Correction to “Unraveling the Role of Base and Catalyst Polarization in Alcohol Oxidation on Au and Pt in Water”

ACS Catal. 2018, 8, 12, 11716-11721. DOI: 10.1021/acscatal.8b03494

The authors regret that the above paper contains physically spurious data, undetected before publication. The present correction does not change the qualitative results of the original article, and the proposed role of chemisorbed OH⁻ species on the catalytic oxidation of alcohol on Au and Pt surfaces. The correction however changes the adsorption strength of OH⁻ and its coverage: Adsorption is thermodynamically stable only for a coverage below 1/16 ML. This however does not modify the role of OH⁻ to polarize the metal surface.

Page 11717: Scheme 1.

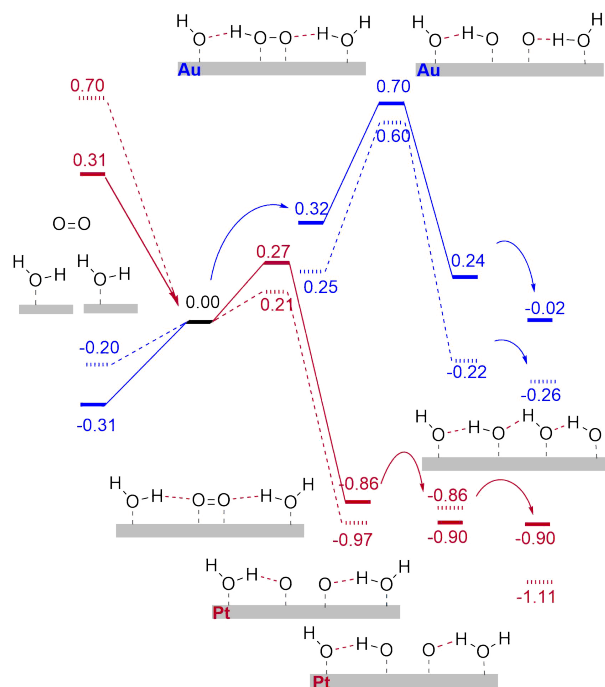
As is shown in Table A, the inclusion of the electronic energy correction ΔE_{shift} causes an increase on the adsorption energy of around 1.30 eV, which corresponds to the value of the electronic energy correction we mentioned before. Then, the adsorption of OH⁻ is not exergonic anymore on a p(3×3) cell. However, the adsorption of this anion is still feasible, but at a lower coverage. It becomes athermic for a coverage around 1/25ML if the ZPE is not included. The inclusion of the ZPE correction renders adsorption more favorable by 0.14 eV, then the adsorption of OH⁻ becomes favorable at a coverage of 1/16ML. Hence, in the following computation, the ZPE correction is taken into consideration to avoid the high CPU cost of a p(5×5) supercell and reach an improved Gibbs Free energy profile using a p(4×4) cell. The corrected schemes and tables appear below along with the accompanying caption. Also, the description of the schemes

and the table are needed to be changed in text according to the corresponding values.

Scheme 1. O₂ activation in presence of water.

^aGibbs free energy profiles (in eV) at 25°C are shown on Au(111) (in blue) and on Pt(111) (in red) in absence (straight lines) and in presence (dashed lines) of a basic environment. All proton transfers are “barrier-less” (with the energy of transition states not higher than the reaction energy, or the barrier is lower than 0.05eV) and thus are indicated by a curved arrow. O₂ adsorption is shown with a straight arrow.
